APPLICATION NO.	FILING DATE	FIRST NAMED INVENTOR	ATTORNEY DOCKET NO.	CONFIRMATION NO.
10/649,242	08/27/2003	David R. Sander	29939/03015	6017
7590	10/05/2005		EXAMINER	
James P. Zeller MARSHALL, GERSTEIN & BORUN LLP Sears Tower, Suite 6300 233 S. Wacker Drive Chicago, IL 60606-6357			LHYMN, EUGENE	
			ART UNIT	PAPER NUMBER
			3727	
DATE MAILED: 10/05/2005

Office Action Summary

DETAILED ACTION

Figure 1: Lippisch (US Des. 372568)

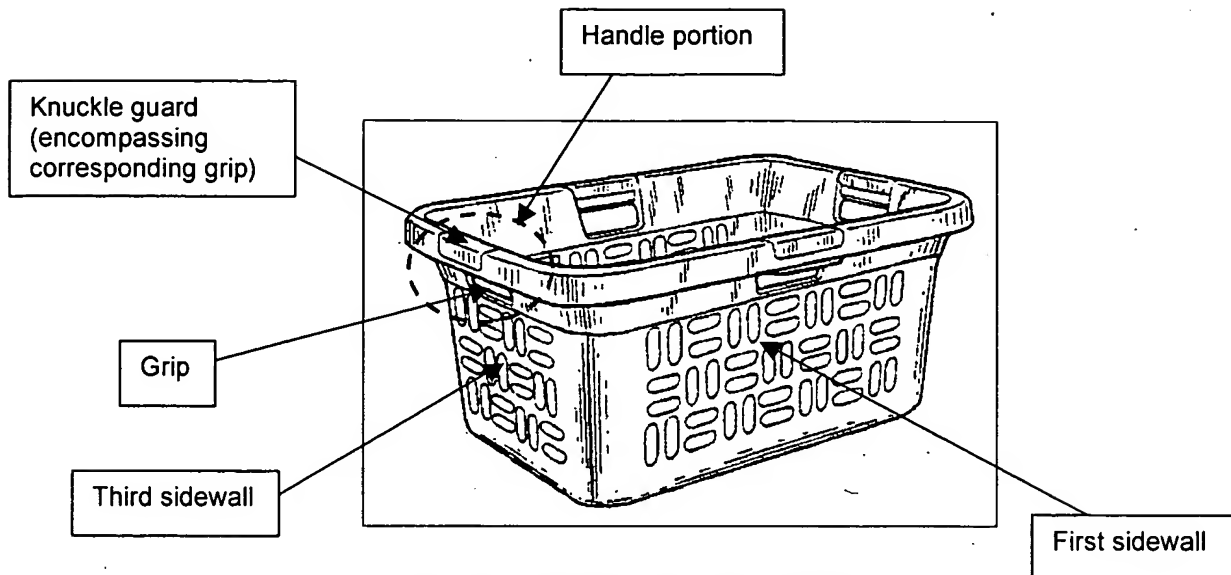
4. Claims 1-5 and 13-17 are rejected under 35 U.S.C. 102(b) as being anticipated by Lippisch (US Des. 372568). With respect to claim 1, Lippisch discloses the following:

- A bottom wall with an outer periphery (Fig. 1 below)
- A contiguous sidewall extending up from the outer periphery of the bottom wall and defining an interior of the laundry basket (Fig. 1 below)
- A first handle on a portion of the contiguous sidewall including a first grip (Fig. 1, the sidewall apertures wherein the lowermost edge of each aperture is the first grip) and a first knuckle guard disposed spaced outwardly from the first grip in a direction away from the interior of the basket (Fig. 1, wherein the knuckle guard is defined by the outwardly extending sidewall portion of the outer rim)

With respect to claim 2, Lippisch discloses the contiguous sidewall including a first, second, third, and fourth sidewall extending up from the bottom wall, as shown below in Fig. 1.

With respect to claim 3, Lippisch discloses the contiguous sidewall being substantially rectangular, wherein the first and second sidewalls are relatively longer than the third and fourth sidewalls (Fig. 1 below).

With respect to claim 4, Lippisch discloses a second handle formed on an upper end of the contiguous sidewall opposite the first handle, the second handle including a second grip and a second knuckle guard disposed spaced outward from the second grip in a direction away from the interior of the basket, as shown below in Fig. 1.

With respect to claim 5, Lippisch discloses a third handle attached to the third sidewall and including a third grip and knuckle guard, which is disposed outward from the third grip in a direction away from the interior of the basket, as shown below in Fig. 1.

With respect to claim 13, Lippisch discloses the first knuckle guard being a bar spaced from and encompassing one side of the first grip, as shown in Fig. 1 below.

- A base including an outer periphery
- A first, second, third, and fourth sidewall, each one extending up from the outer periphery of the base, defining an interior of the basket
- A first handle on a portion of the contiguous sidewall including a first grip (Fig. 1, the sidewall apertures wherein the lowermost edge of each aperture is the first grip) and a first knuckle guard disposed spaced outwardly from the first grip in a direction away from the interior of the basket (Fig. 1, wherein the knuckle guard is defined by the outwardly extending sidewall portion of the outer rim)
- A second handle including a second grip and knuckle guard disposed outwardly from the second grip in a direction away from the interior of the basket (Fig. 1 below)

With respect to claim 15, Lippisch discloses a third handle formed on an upper end of the third sidewall, the third handle including a third grip and third knuckle guard (Fig.1 below)

With respect to claim 16, Lippisch discloses the first and second knuckle guards being a bar spaced from and encompassing one side of the grips, as shown in Fig. 1 below.

- A base including an outer periphery (Fig. 1 below)
- A contiguous sidewall extending up from the outer periphery of the bottom wall and defining an interior of the laundry basket (Fig. 1 below)
- A first handle on a portion of the contiguous sidewall including a first grip (Fig. 1, the sidewall apertures wherein the lowermost edge of each aperture is the first grip) and a first knuckle guard disposed spaced outwardly from the first grip in a direction away from the interior of the basket (Fig. 1, wherein the knuckle guard is defined by the outwardly extending sidewall portion of the outer rim)
- A second handle formed on an upper end of the contiguous sidewall opposite the first handle, the second handle including a second grip and a second knuckle guard disposed spaced outward from the second grip in a direction away from the interior of the basket (Fig. 1 below)
